Date	October 2022
Product	Kontainer V4
Level	Lox

SAFETY NOTE

Problème sur le fourreau guide des élévateurs sur le Kontainer V4.

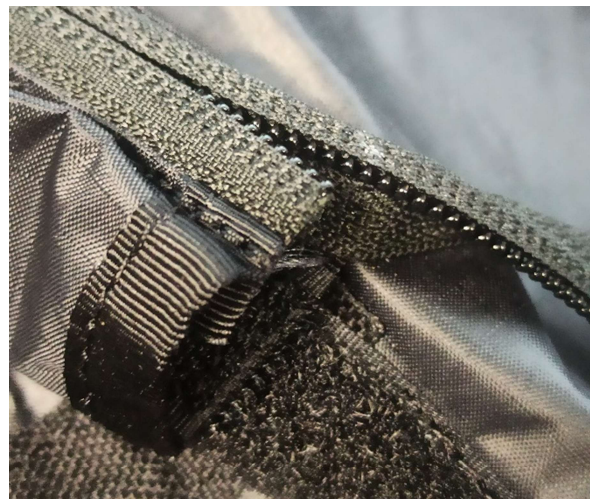
Following a pilot's feedback during the installation of his rescue parachute in the V4 Kontainer, and after checking that it was working properly, it was found that a slight defect in the riser guide sleeve could lead to damage to the equipment in the event of the rescue parachute being used in a real situation.

***There is no risk to the correct deployment of the rescue parachute,
but there is a risk that the risers may not exit the sheath correctly.***

- Open the Kontainer V4 and view the central area where the sleeve is connected via Velcro.

- Cut off the "short" part of the zip that protrudes from the sleeve with a scissor.

- Check that the zip is flush with the sleeve, and that the slider can remain in place on the other side when the zip is fully closed.
